MEMORANDUM

DATE: November 14, 2018

RE: REVIEW OF WEKIVA RIVER HYDROLOGY AND HYDRAULIC MODELING

Figure 1. Rainfall WDM Annual Totals

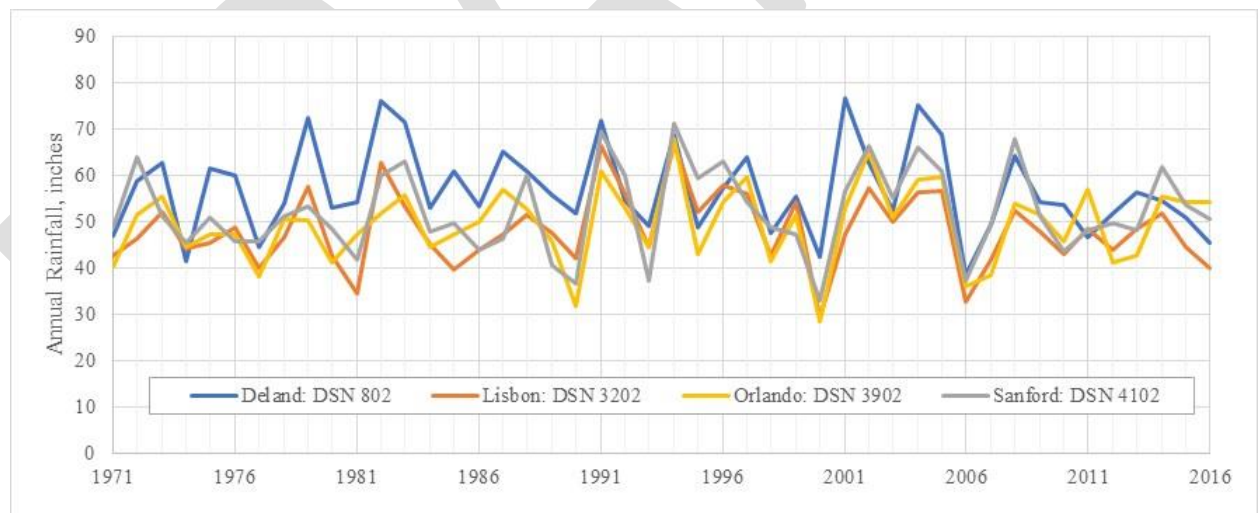
The HSPF .uci files referenced 4 rainfall data sets from DSN 802 (Deland), DSN 3202 (Lisbon), DSN 3902 (Orlando) and DSN 4102 (Sanford). Each timeseries was exported from the RainModel_2017.wdm file and summed by year, as shown below, and compared to Figure 6 of Seong and Wester (2018). The annual totals matched, however Figure 6 of Seong and Wester (2018) should be modified to add the Sanford station to the legend. Examination of the individual hourly timeseries found that the time series between stations matched at times, which was due to gap filling techniques. Additional detail is needed in the document regarding the gap filling techniques used and the performance of the gap-filling techniques. If error statistics are available for gap-filling, they should be presented in the report. If error statistics are not available, they should be calculated by applying the gap-filling technique to a period of the record with observed rainfall and calculating the difference between the observed rainfall and the rainfall simulated with the gap-filling. Overall, the rainfall totals were consistent between gauges and were within reasonable and expected ranges for Florida hydrology.

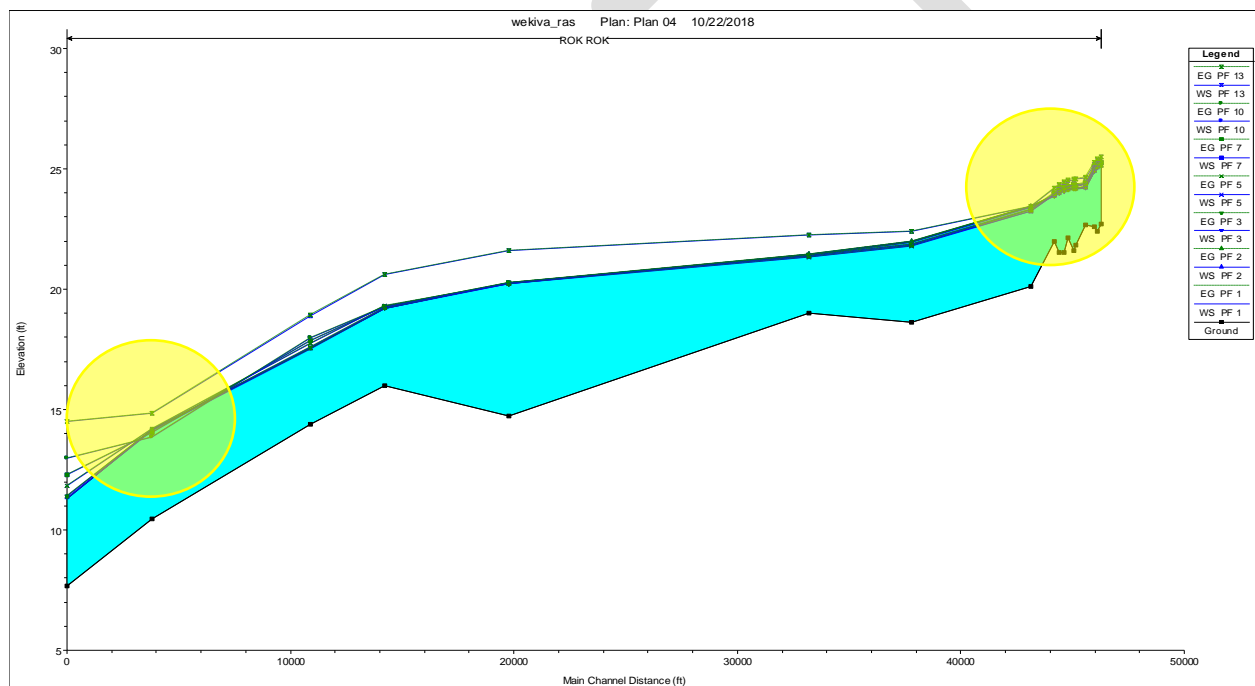
Flow and stage plots were examined as appropriate in both models to look for modeling instabilities. No model instabilities were noted in the HSPF model. Slight instabilities were noted in the HEC-RAS model as it relates to the simulated stages. As shown, stages are expected to increase as percentile flows increase. There are instances where the flow profiles for various percentile flows intersect each other. Upon further examination of the flow profiles, it was noted that this is due to inconsistencies in the flow profiles based on the observed data. For example, the flow at ROK4 for PF 12 is 72.5 cubic feet per second (cfs), while the flow at ROK4 for PF11 is 79.5 cfs. The corresponding flows downstream at XS2 are 992.4 cfs and 896.8 cfs. While this is to be expected since it is a steady-state model with flow profiles based on observed data, it may be helpful to smooth the flow profiles so that inconsistencies are not simulated (e.g. a higher stage at a lower flow profile).

Figure 2. Cross Section Example

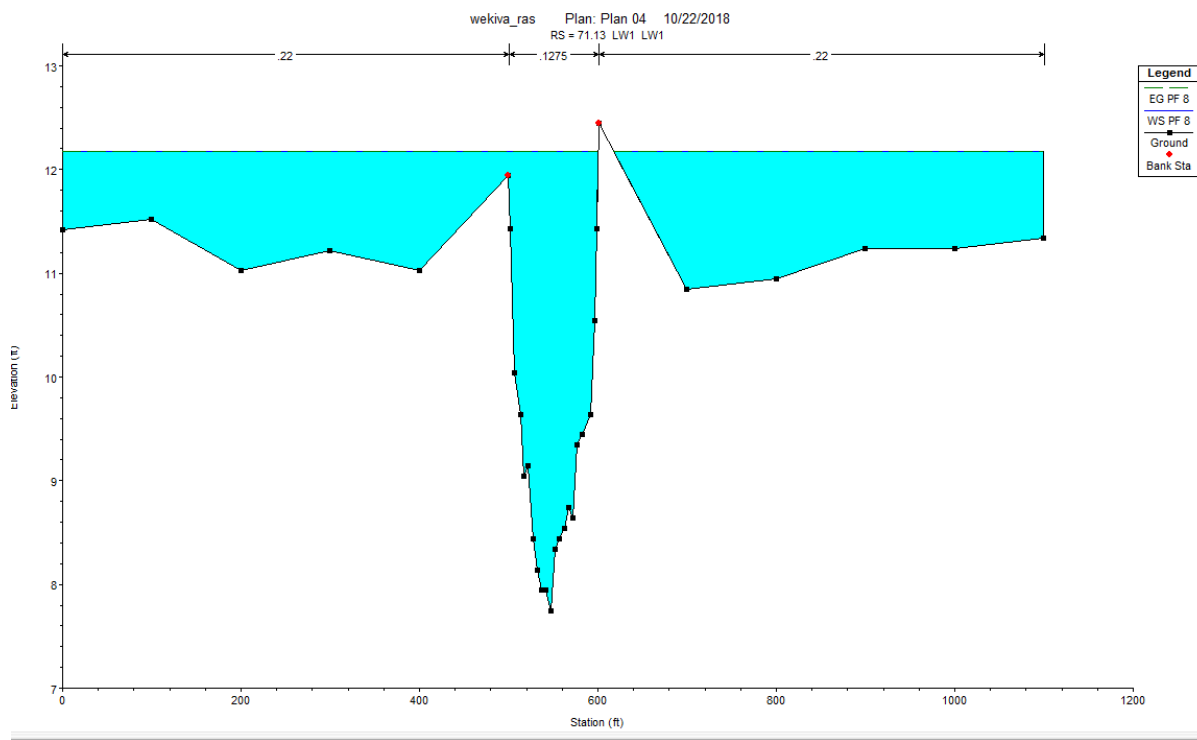
There were no warning or error messages present in the HSPF model. There were several warnings noted in the HEC-RAS simulation related to the potential need for additional cross sections due to the conveyance ratio being outside of the expected range. Additional cross sections could be added if desired, but this should minimally affect the overall model performance. Several errors were noted for cross sections that needed to be extended for the computed water surface, as shown in the example cross section below. These cross sections should be extended so that the water surface is fully contained within the cross-

sectional area. Although this should only minimally affect results, it is good modeling practice.
